CITY OF FORT LAUDERDALE

# DEVELOPMENT REVIEW COMMITTEE

CASE NO. UDP-S24036

<b>CASE:</b>	UDP-S24036
<b>MEETING DATE:</b>	May 28, 2024
<b>REQUEST:</b>	Site Plan Level II Review: 10-Unit Multifamily Residential Development with 586 Square Feet of Commercial Use in the Northwest Regional Activity Center
<b>APPLICANT:</b>	ILFC Corporation
<b>AGENT:</b>	Yanina Mauro
<b>PROJECT NAME:</b>	DL Design
<b>PROPERTY ADDRESS:</b>	1102 NW 6th Street
<b>ZONING DISTRICT:</b>	Northwest Regional Activity Center-Mixed Use west (NWRAC-MUw)
<b>LAND USE:</b>	Northwest Regional Activity Center
<b>COMMISSION DISTRICT:</b>	3 - Pamela Beasley-Pittman
<b>NEIGHBORHOOD ASSOCIATION:</b>	Historical Dorsey-Riverbend Civic Association
<b>CASE PLANNER:</b>	Michael Ferrera

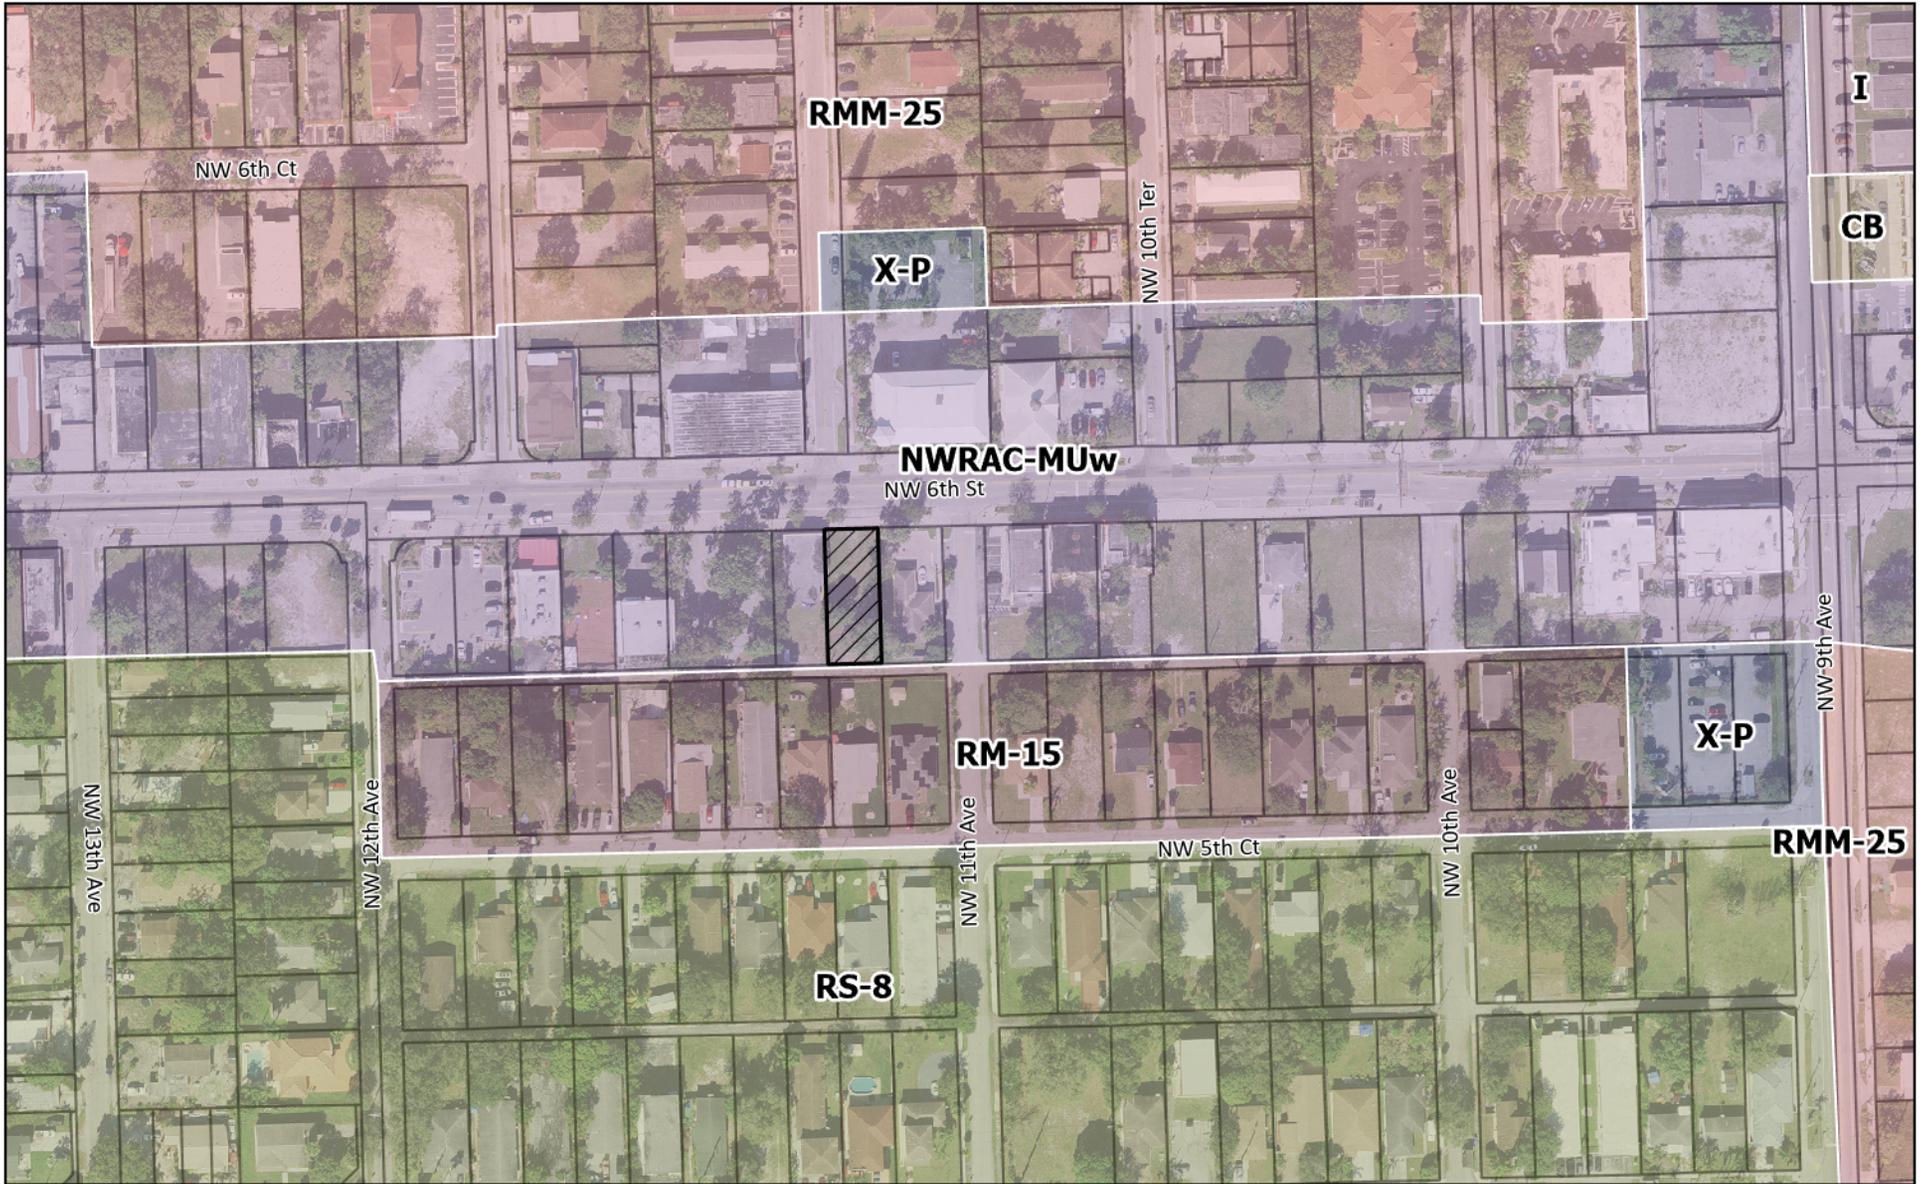
- q. *B-24, Balconies and bay windows animate residential building facades. Consider adding balconies where appropriate.*
